**APPLICATION FOR PERMISSION
UNDER SECTION 16 OF
THE TOWN PLANNING ORDINANCE
(CAP.131)**

For Official Use Only 請勿填寫此欄	Application No. 申請編號	A1115K/381
	Date Received 收到日期	- 9 JUN 2022

(a) Full address / location / demarcation district and lot number (if applicable) 詳細地址/地點/丈量約份及地段號碼 (如適用)	洪水橋田廈路新生村丈量約份第124 約地段第1225號(部分)及第1226號餘段(部分)
(b) Site area and/or gross floor area involved 涉及的地盤面積及/或總樓面面積	<input checked="" type="checkbox"/> Site area 地盤面積 2025 sq.m 平方米 <input checked="" type="checkbox"/> About 約 <input checked="" type="checkbox"/> Gross floor area 總樓面面積 128 sq.m 平方米 <input checked="" type="checkbox"/> About 約
(c) Area of Government land included (if any) 所包括的政府土地面積 (倘有) sq.m 平方米 <input type="checkbox"/> About 約

Government Departments' General Comments

消防裝置建議計劃圖

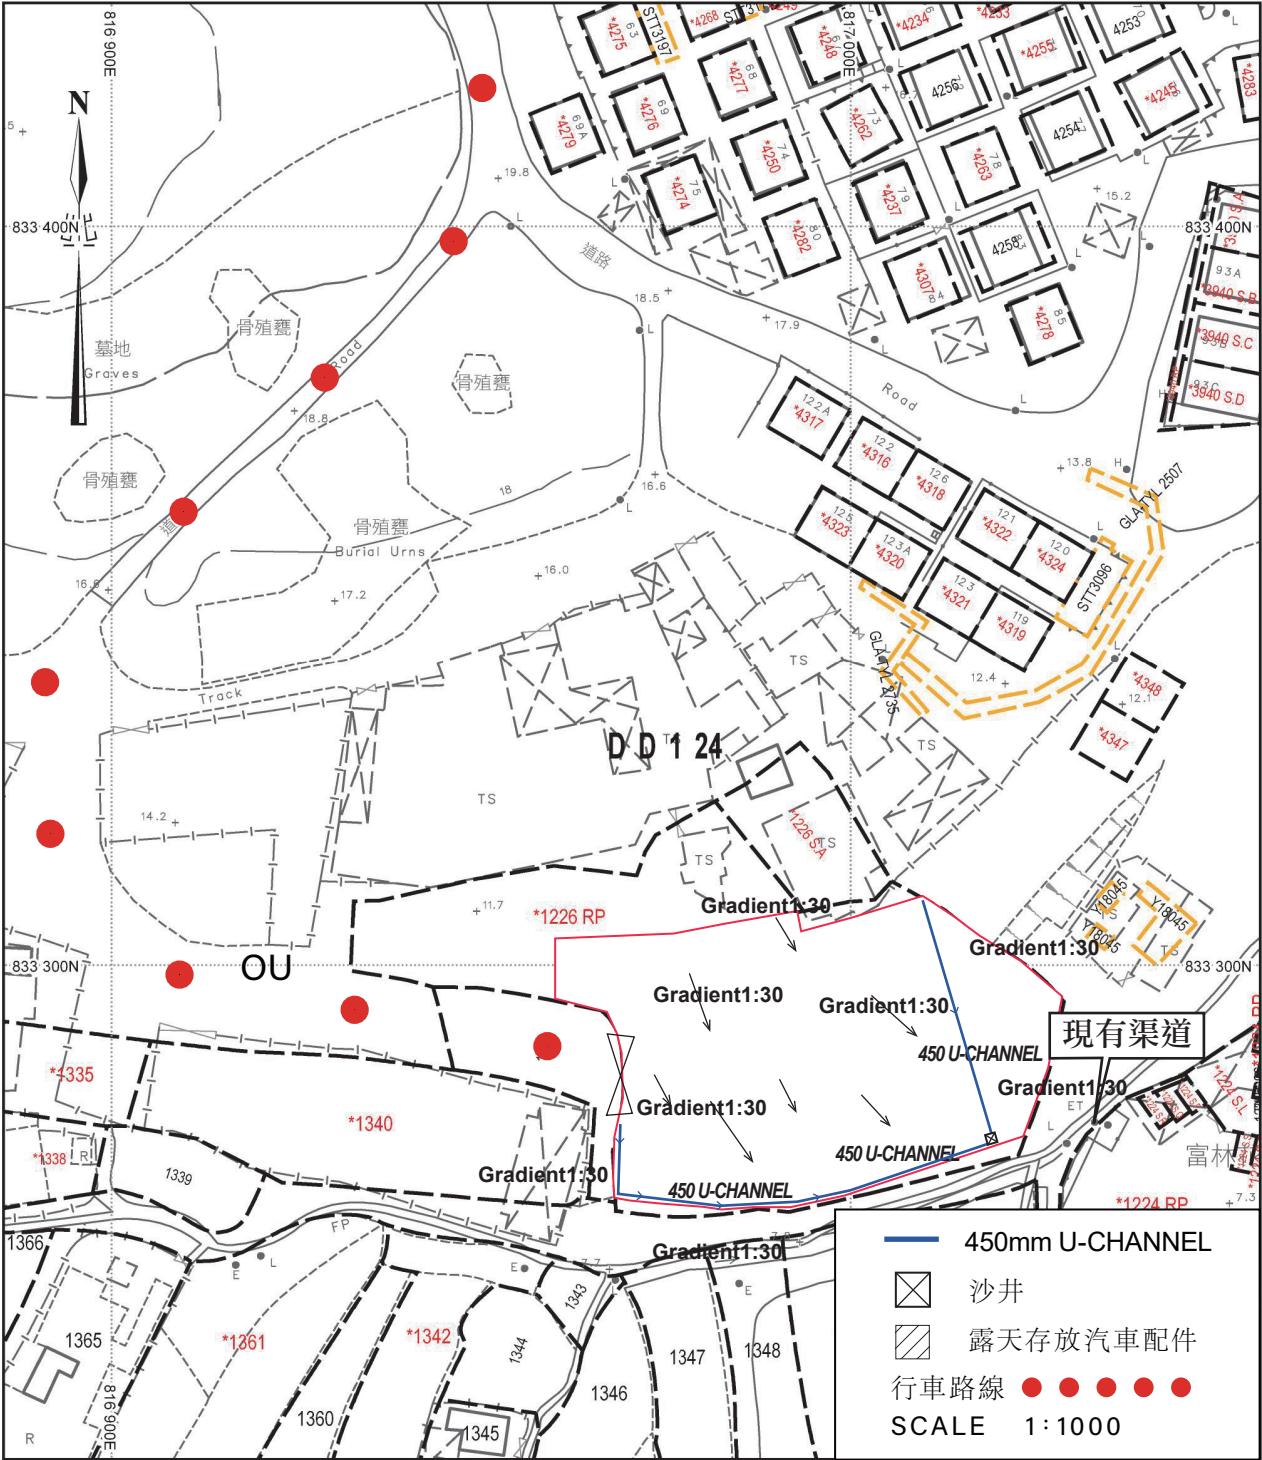
- no in-principle objection to the proposal subject to fire service installations (FSIs) being provided to the satisfaction of his department; and
- in consideration of the design/nature of the proposal, the applicant is advised to submit relevant layout plans incorporated with the proposed FSIs to his department for approval.

- (i) to note the comments of the Director of Fire Services (D of FS) that:
- (i) the applicant is advised that the layout plans should be drawn to scale and depicted with dimensions and nature of occupancy and the location of where the proposed FSIs are to be installed should be clearly marked on the layout plans; and

渠務建議計劃圖

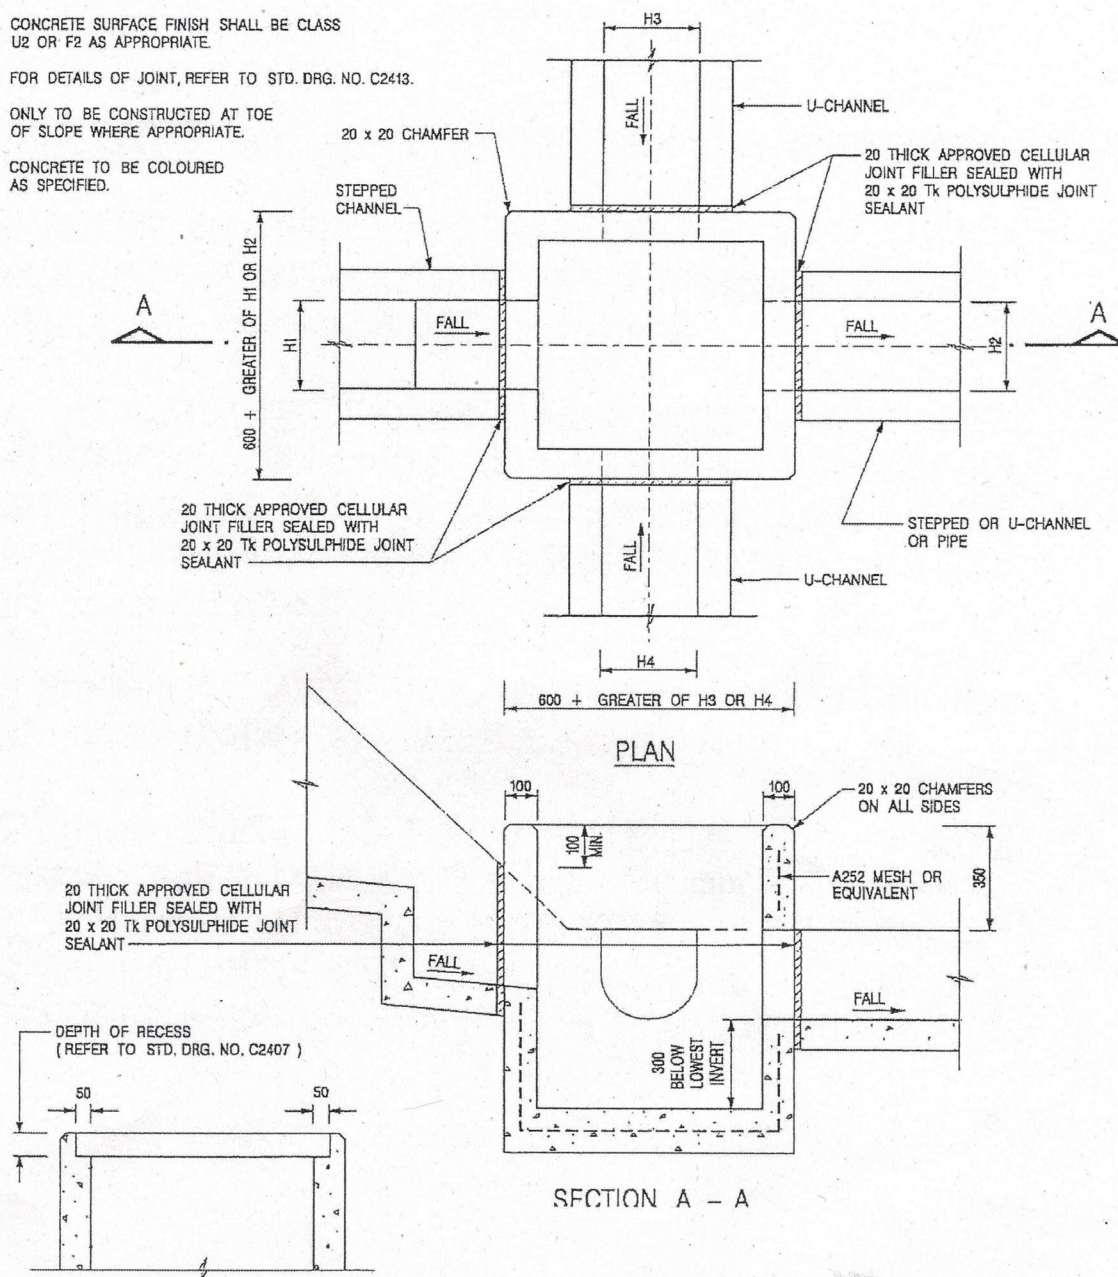
- no objection in principle to the application from drainage point of view; and
- should the application be approved, conditions should be stipulated requiring the applicant to maintain the existing drainage facilities and submit a condition record of the existing drainage facilities to his satisfaction.

- (g) to note the comments of the Chief Engineer/Mainland North, Drainage Services Department (CE/MN, DSD) that the required condition record should include coloured photos showing the current condition of the drainage facilities and a layout plan indicating the locations of the photos taken. The submitted photos should cover all internal surface channels, catch pits, sand traps, manholes, terminal catch pits/manholes and the downstream discharge path as indicated on the submitted drainage proposal;
